Regarding the improvements to the District Hospital Building at Kolar

D.O. Letter No. 239, dated 7th November 1929 from the Superintending Engineer, Mysore Circle, to the Senior Surgeon in Mysore.

Site Plan of the Civil Hos of Kolar

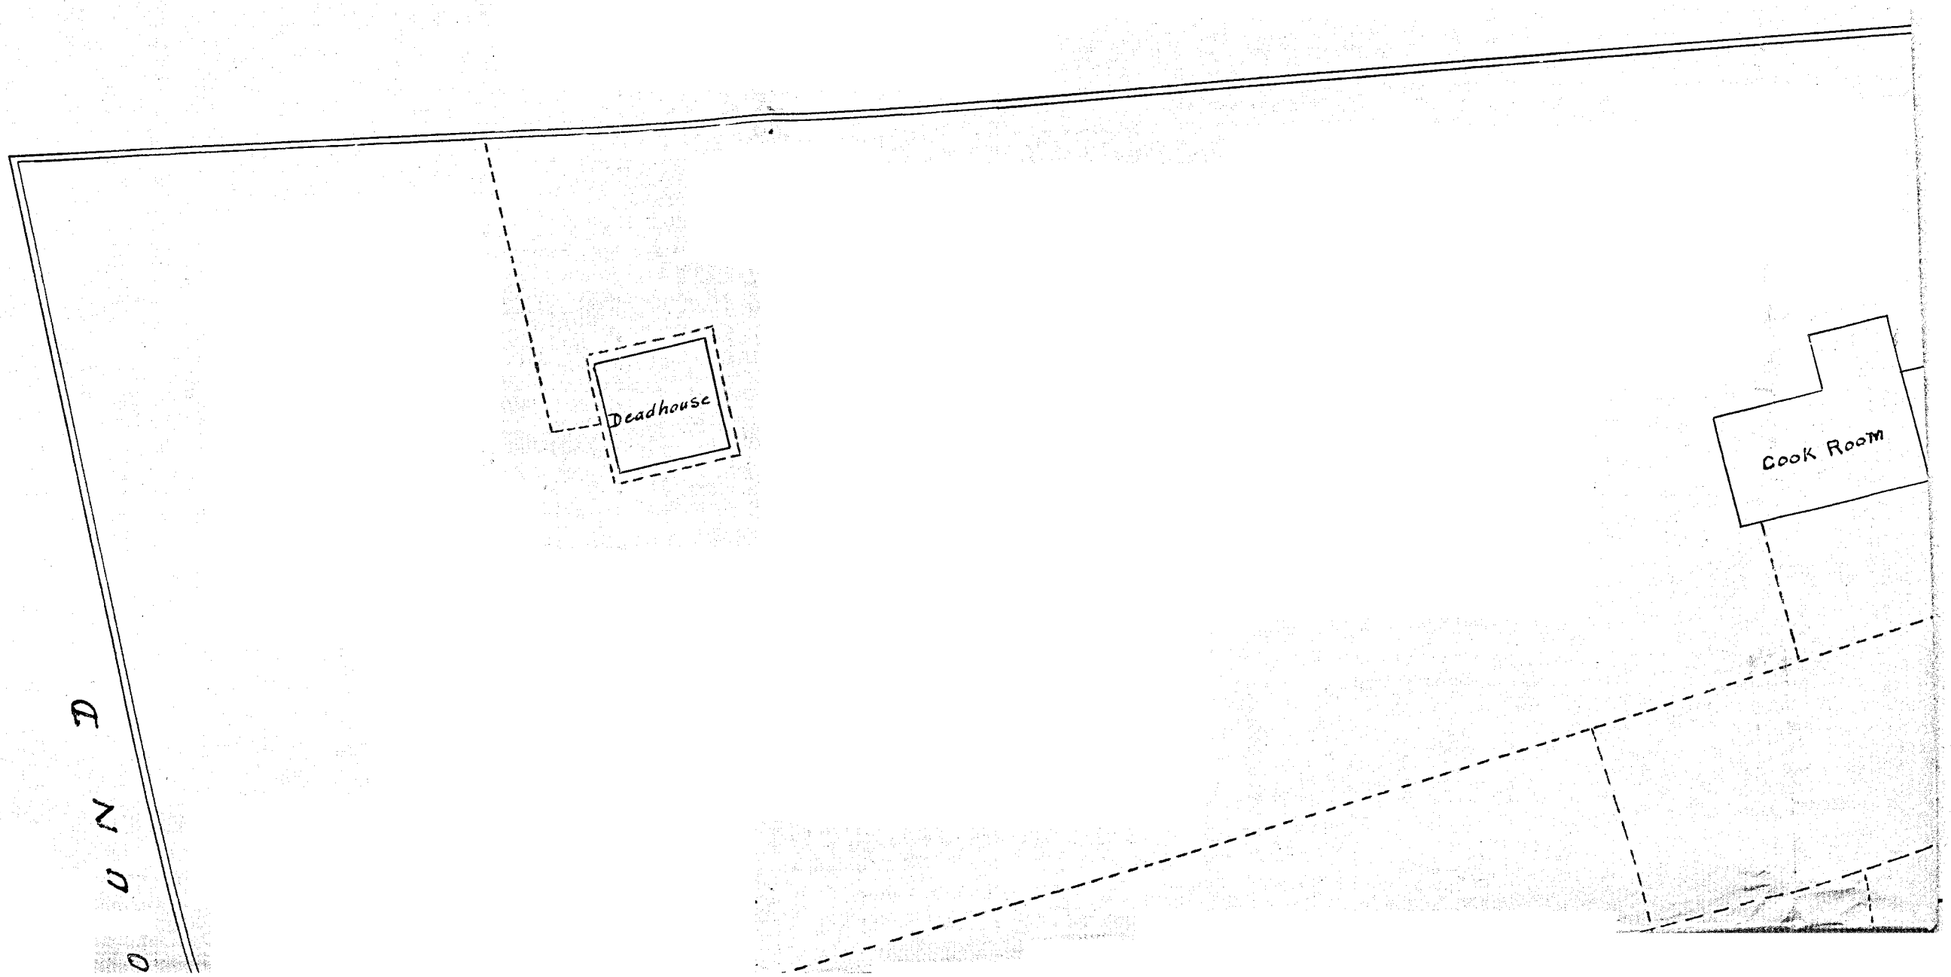
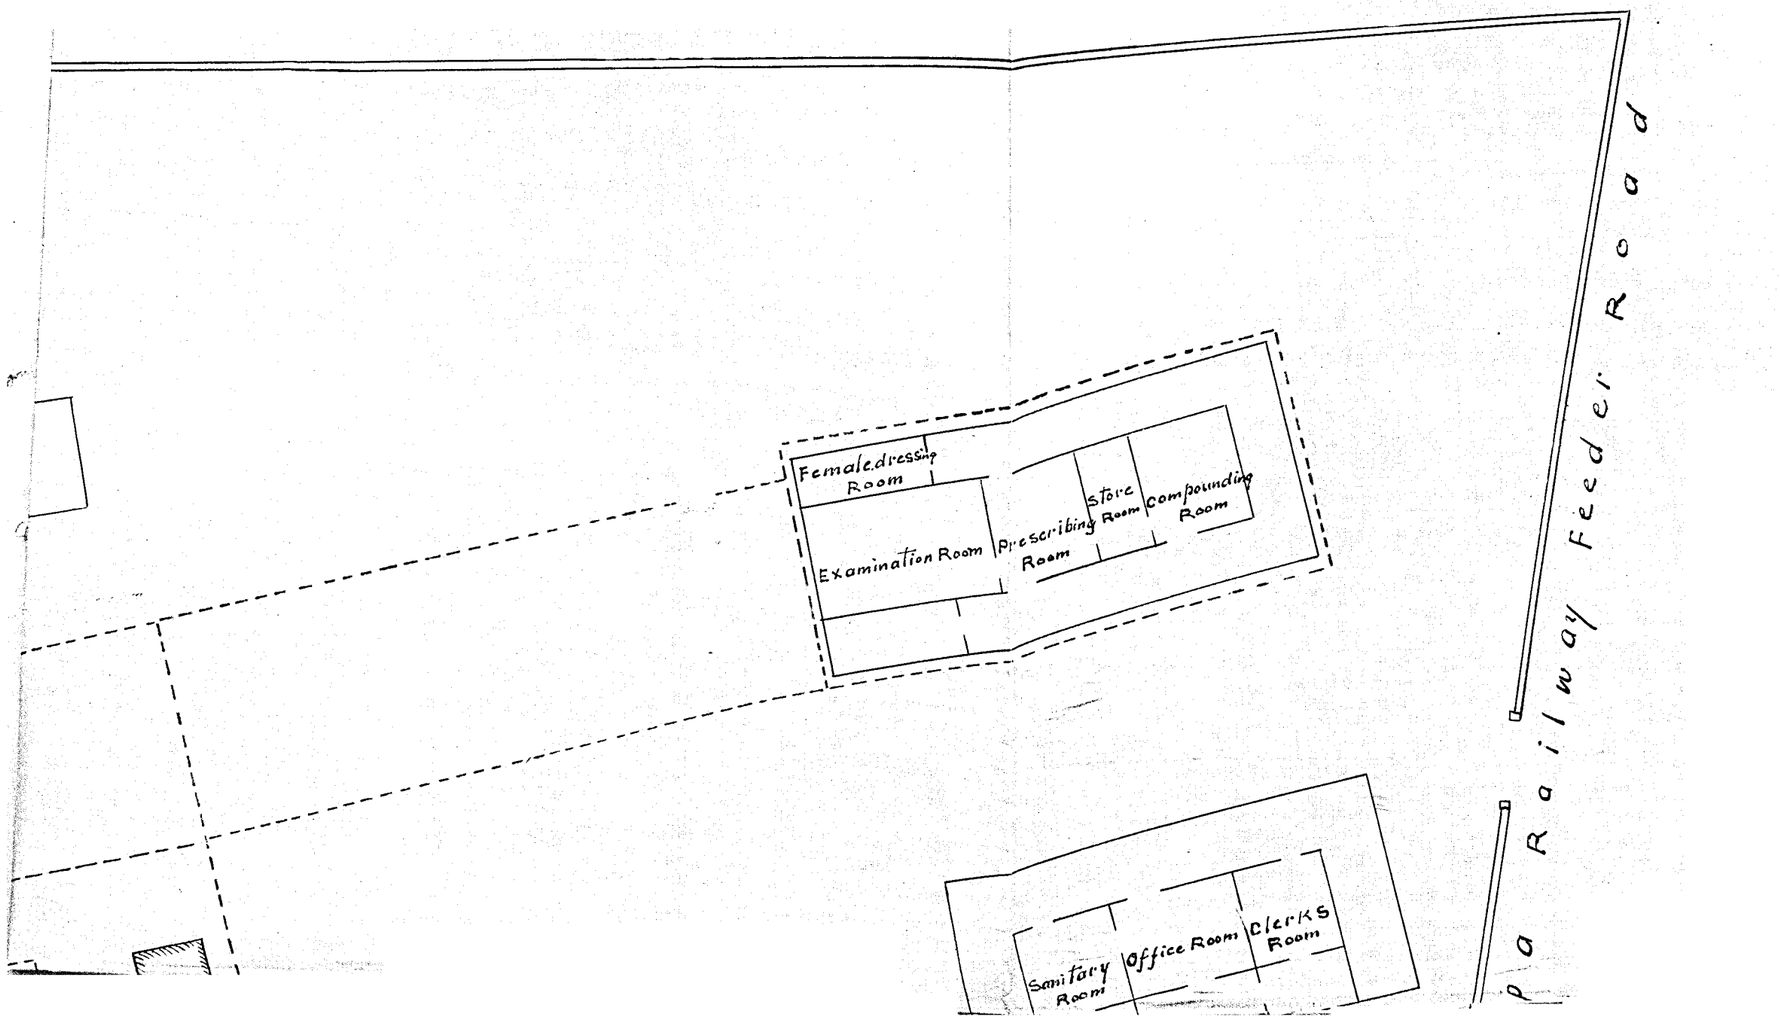
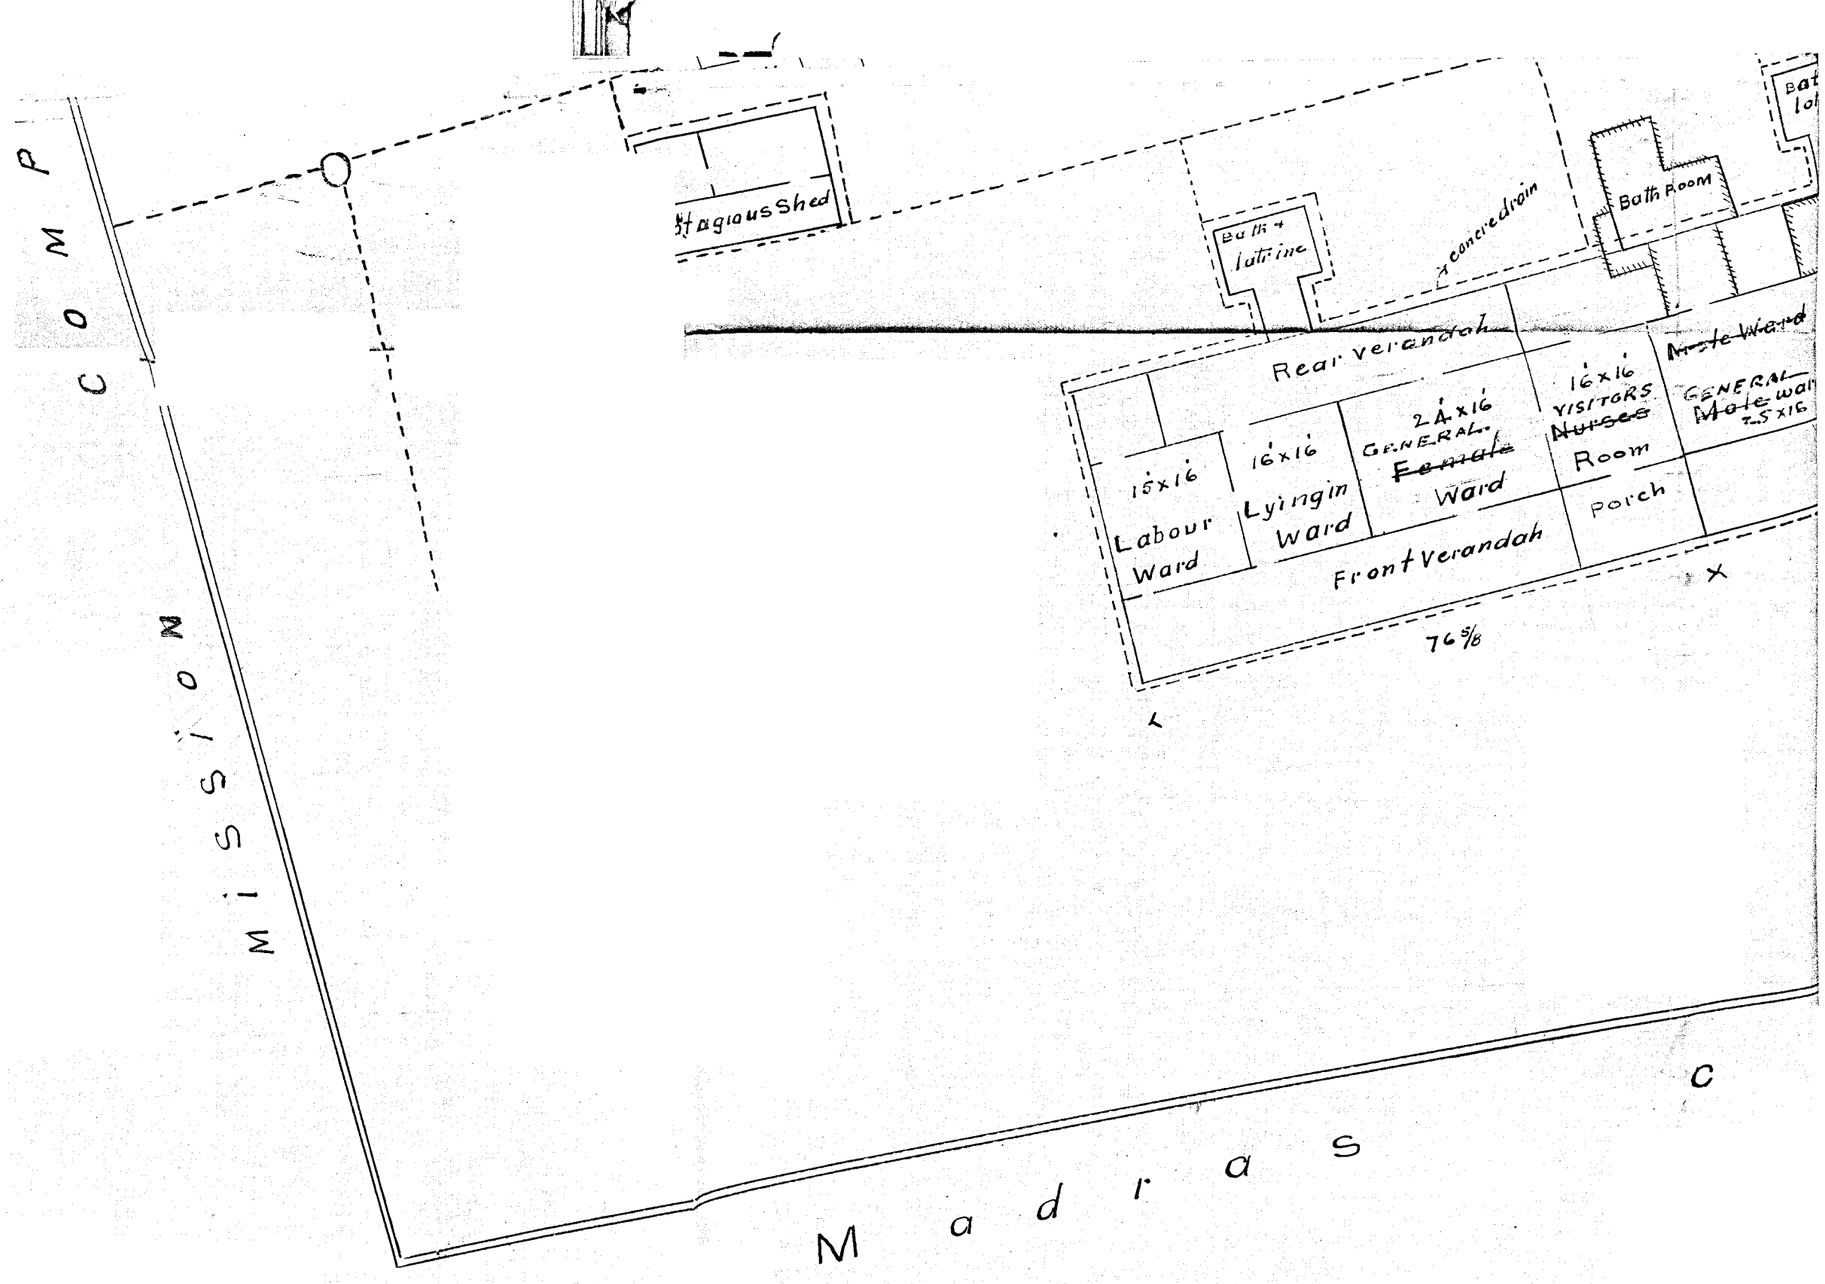
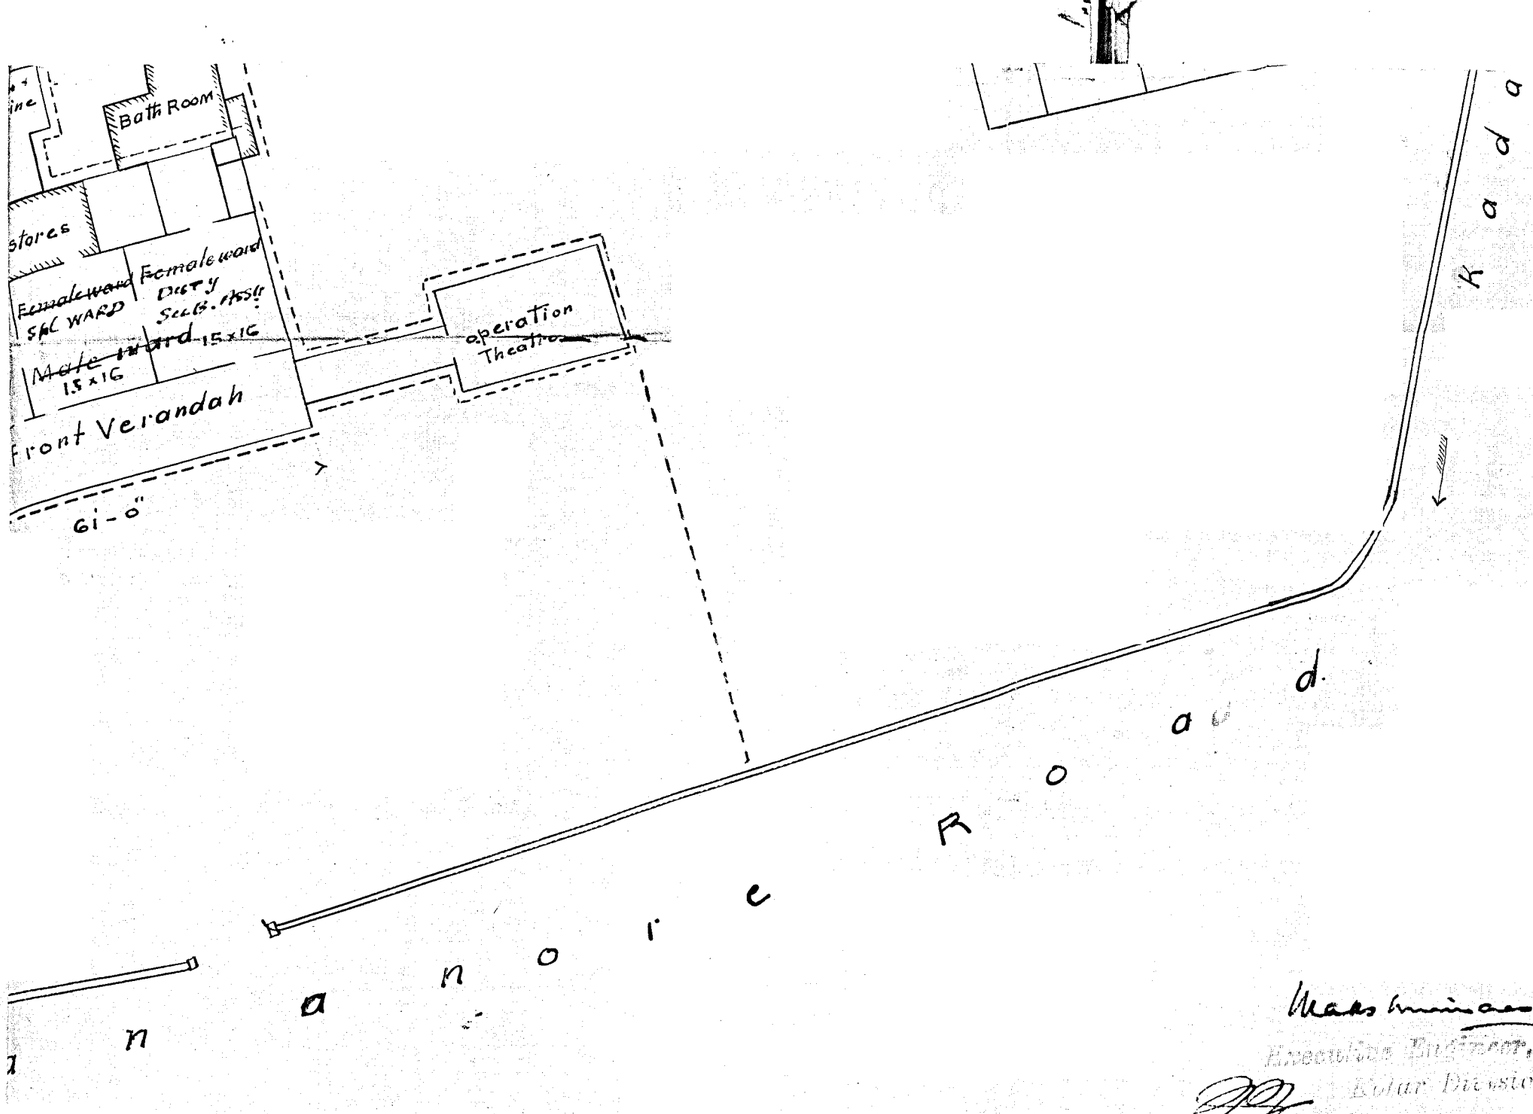
The estimate of Rs. 23,600/- herewith returned is not merely for the simple addition of a block of three rooms with verandahs in front and rear as observed by you but it includes the cost of improvements amounting to Rs.7,470/- to treat the existing building as per the approved design furnished by the Architect. The improvements consist of remodelling the whole roof with new wood work, the hall portion being tiled and the verandhas provided with terraced roof.

The cost of the additional buildings proper will be Rs.16,230/- for a plinth area of nearly 3200 sq. feet which works to be Rs.5/- per s.ft.

There are certain structural differences between the buildings as constructed at Tiptur and the one proposed for Kolar. While brick in mud is used in the former, brick in mortar is proposed in the latter. While Mangalore flooring tiles are provided for in the former marceilles tiles are provided for in the latter. Very high class work is provided for in the estimate for the Kolar Hospital extension. Cement plastering and oil painting have been proposed for the walls and an ornamental terrace verandha has been included in the design. As the Hospital will face the important Madras-Bangalore Road, a nice elevation is called for in my opinion.

I find that a depth of 5' has been proposedfor the foundation this of course depends on the soil. If a hard soil is met with the depth will be reduced. If Marceilles tiles flooring is not required and if the depth of foundation is also reduced and several slight changes are made re. the material for plastering, the estimate amount for the additional ward may with suitable reduction of rates be brought down by Rs.2,500/- Similar reduction for improvements for the existing portion may effect a savings of Rs.750.

If you consider that a thorough change in the design is necessary, I request you will send a sketch showing your requirements when a fresh plan and estima e will be ordered to be prepared.
